XC27x5X Derivatives

16/32-Bit Single-Chip Microcontroller
with 32-Bit Performance
XC2000 Family / Base Line

Errata Sheet

V1.6 2013-06

Figure 1 Context Switch with Pointer Passing in R15

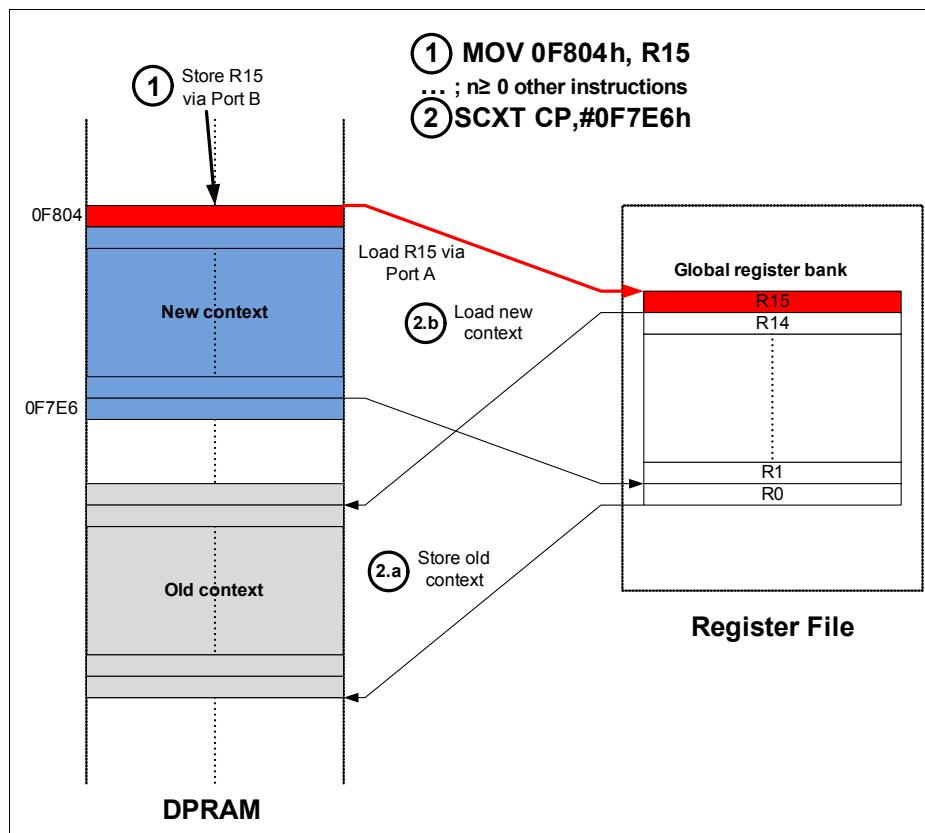
2. An explicit software write operation (i.e. no context switch) to L_1 and/or L_2 is performed, and
3. The Context Pointer (register CP) is modified (e.g. by MOV/POP/SCXT CP, ...) in one of the following instructions, leading to a context store (old context) and a context load (new context) of the global bank into/from DPRAM, and
4. One of the General Purpose Registers Rx with an odd register number x ($x = 1, 3, \dots, 15$) is loaded from locations L_1 or L_2 .

In this case, the contents of Rx may be incorrect.

This scenario may typically occur at the beginning of interrupt routines when a GPR (e.g. R15 used as user stack pointer) is saved into the new GPR context in DPRAM, as shown in the following **Figure 1**.

- On **assembler** level, do not perform a context switch of the global register bank in case locations in the DPRAM corresponding to the location of a register Rx with an odd register number are written by software (see example for critical scenario in [Figure 1](#)).
- With the **compiler** of the TASKING VX-toolset, do not use the `__registerbank(...)` function qualifier to define a **global** register bank.
- With the **compiler** of the “Classic” TASKING C166/ST10 toolset, no workaround for this scenario is required (see analysis above).
- With the **compiler** of the Keil C166 toolset, no workaround for this scenario is required (see analysis above).

Figure 2 Critical application reset sequence

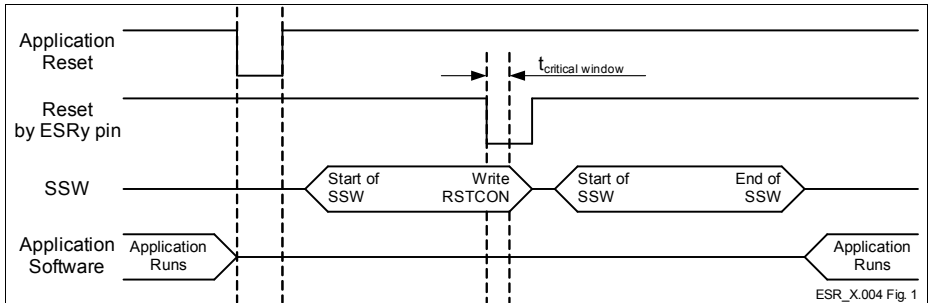
`SCU_RSTCONx` registers are reset only by Power-On, but they may be wrongly affected after a second application reset requested by an ESRy pin. This may lead to the `SCU_RSTCONx` register values being set to zero, which could unexpectedly disable reset sources within the user application. The conditions which lead to this behavior are:

1. First, an application reset by SW (software), CPU (Central Processing Unit), MP (Memory), WDT (Watchdog Timer) or ESRy (External Service Request y) occurs.
2. Following this, an application reset on an ESRy pin occurs.
3. If the above mentioned ESRy reset occurs during a critical time window of the SSW (startup software), then it's possible that the application will operate with the wrong `SCU_RSTCONx` register value. The critical time window occurs when the SSW is writing the `SCU_RSTCONx` registers, and at the same time, the ESRy reset request is processed by the reset circuitry. The width of this critical window $f_{\text{critical window}}$ is less than 13 cycles.

- Initialize `SCU_RSTCONx` registers by user software after any reset, or
- assure that a second application reset request with an ESR pin does not occur during the critical time window.

Figure 3 Example for a Slow Input Signal

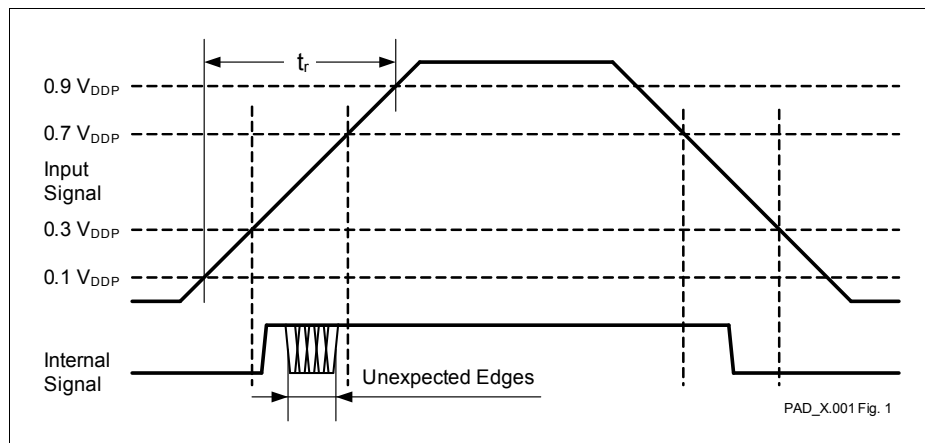
The digital input- and I/O-pins are designed using Schmitt trigger input structures with hysteresis. Even with this structure, it is possible that very slow

rising edges may generate spikes, resulting in unexpected additional edges at the input signal.

The first rising edge in **Figure 3** of the internal signal is always valid. The edges which are marked with “Unexpected Edges” must be ignored.

No generic solution is available for these applications. Add or switch to a software solution.

Figure 5 Rising Edge Detection Approach

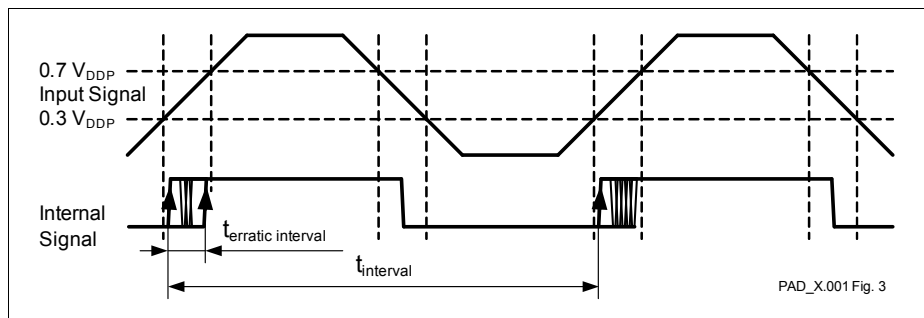
In case of rising edge detection multiple interrupts would be generated when the spike occurs. The time interval since the last interrupt can be measured – if it is very small compared to the expected value, this would indicate a spike and the interrupt should be ignored.

If the time between the rising signal edge and the rising edge caused by a spike $t_{erratic}$ is less than the ISR service time, a workaround would be to clear the interrupt request (IR) flag before the return from interrupt is done. The clearing of the IR flag will avoid a further erratic interrupt.

Figure 7 Alert Interrupt Behavior in case of Bus-Off

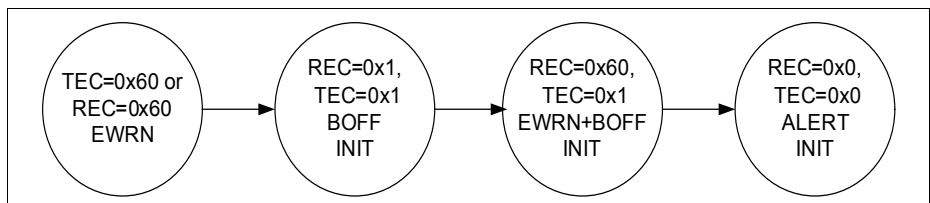
The MultiCAN module shows the following behavior in case of a bus-off status:

Figure 8 Loss of Arbitration

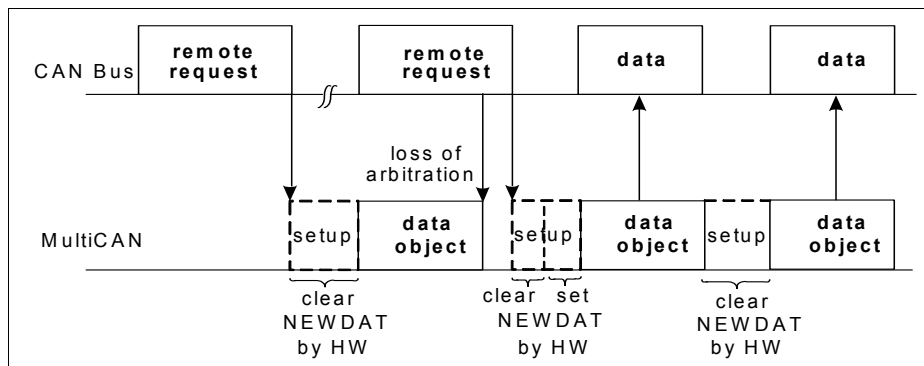
When the appropriate message object (data frame) triggered by the first remote frame wins the arbitration, it will be sent out and `NEWDAT` is not reset. This leads to an additional data frame, that will be sent by this message object (clearing `NEWDAT`).

There will, however, not be more data frames than there are corresponding remote requests.
